TSG-RAN Meeting #10
Bangkok, Thailand, 6 - 8 December 2000

RP-000537

Title: **Agreed CRs to TS 25.211**

Source: **TSG-RAN WG1**

Figure 28: FRadio frame timing and access slot timing of downlink physical channels

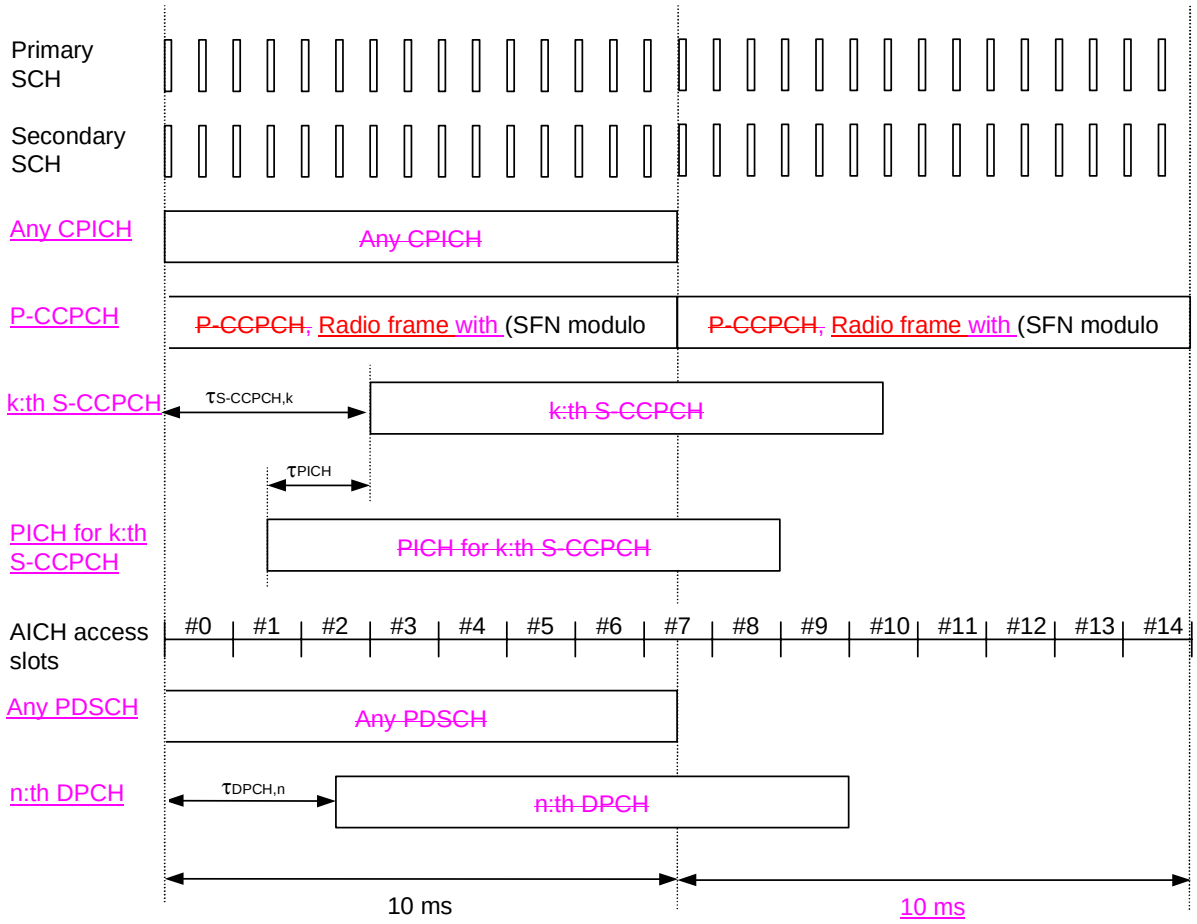
Subject: Clarification of figure 28

Reason for change: Since there has been some misunderstanding of figure 28, the figure has been updated to make clear that e.g. “k:th S-CCPH” refers to the k:th S-CCPCH *physical channel* and not to the k:th radio frame of any S-CCPCH. The same is the case for the n:th DPCH.

Figure 61: Mapping of MASF and PRAs to SIs in CSICH

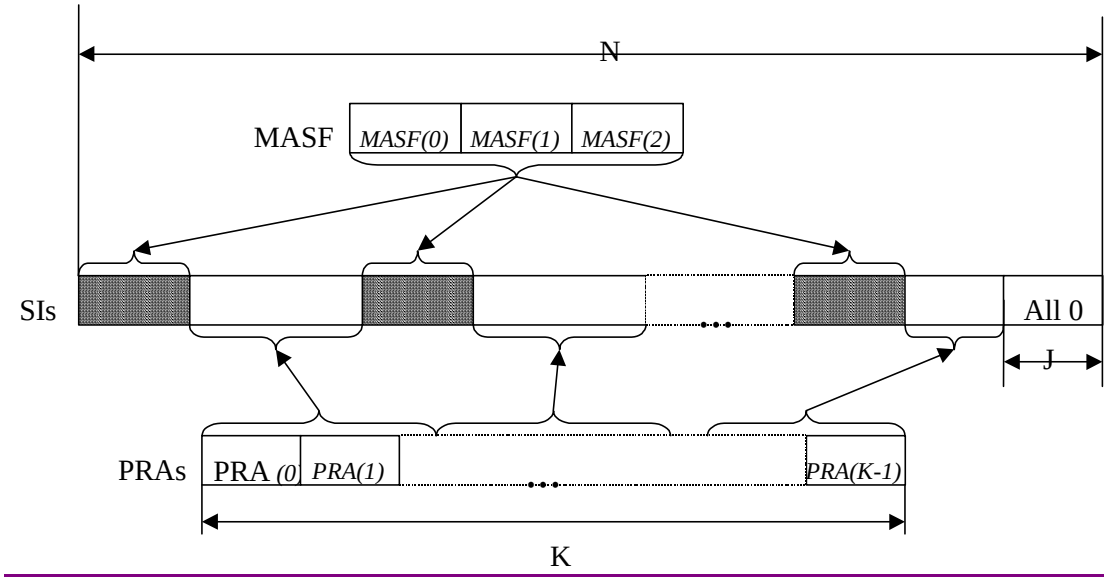
Reason for change: The CSICH information structure description which has been deleted from the Layer 3 TS25331 (in the CR referenced below) is included here in TS25.211. CSICH information is broadcast by Layer 1 in Node B to Layer 1 in UE where it is used in the CPCH access procedure. CSICH information is not available to or used by upper layers.

PRA(n)=1 indicates that the PCPCHn is available, and PRA(n)=0 indicates that the PCPCHn is not available. PRA value for each PCPCH channel defined in a CPCH set shall be assigned to one SI (Status Indicator), and 3-bit MASF value shall be assigned to SIs as shown in Figure 61.

Figure 31: Timing of PCPCH and AICH transmission as seen by the UE, with T_{cpch}= 0

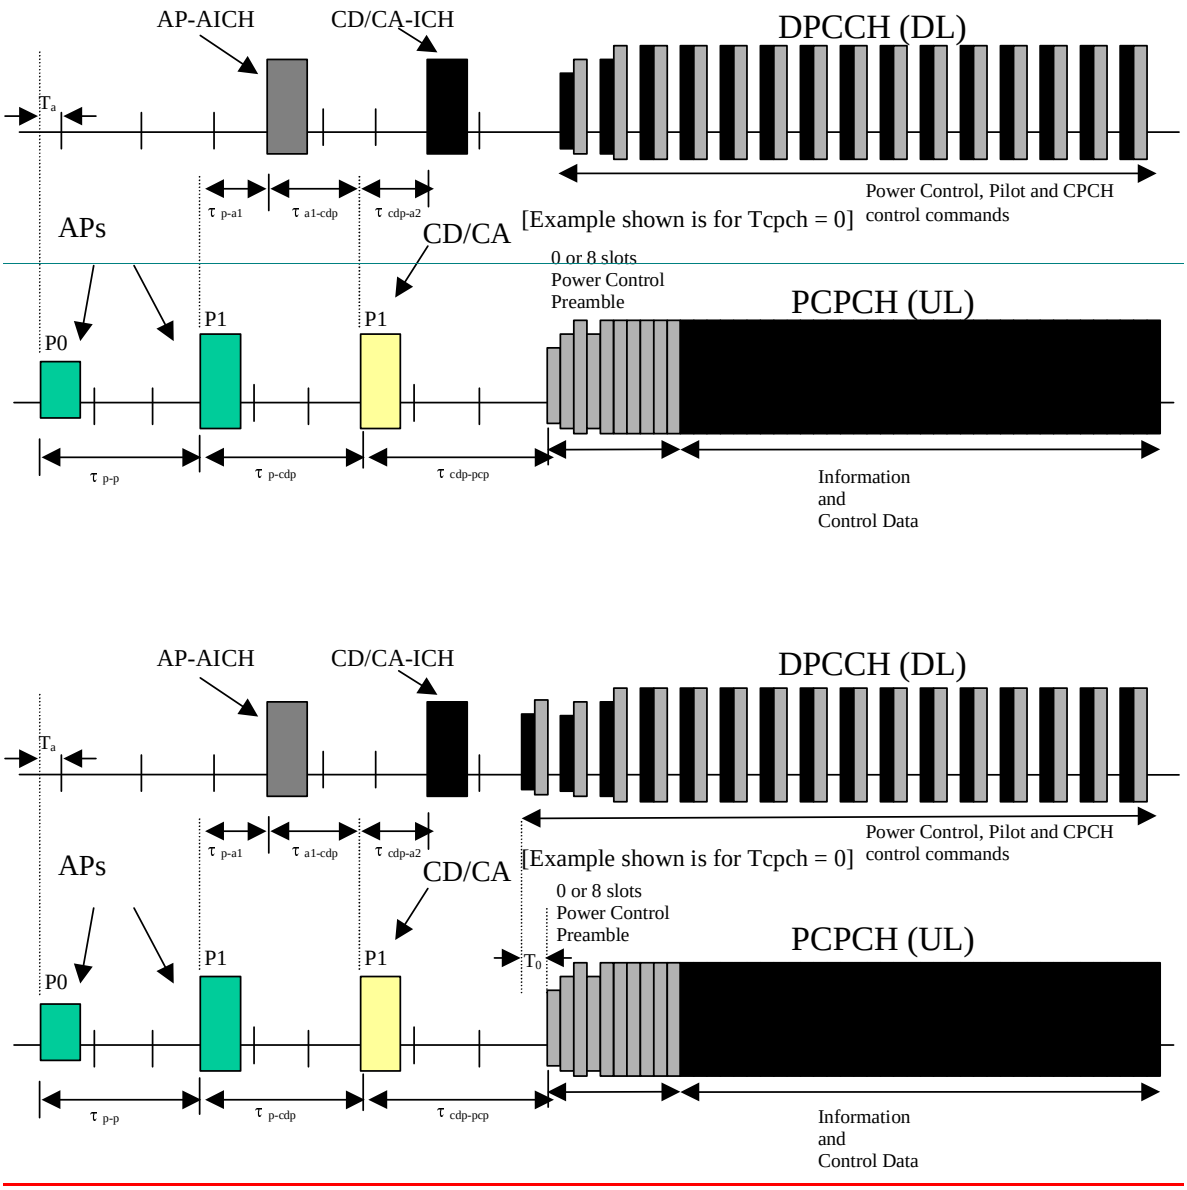
Reason for change: The timing relation between the start of the reception of DL-DPCCH at the UE and the start of the PCPCH power control preamble is defined in this contribution.

The message transmission shall start 0 or 8 slots after the start of the power control preamble depending on the length of the power control preamble.

Figure 31 illustrates the PCPCH/AICH timing relationship when T_{cpch} is set to 0 and all access slot subchannels are available for PCPCH.
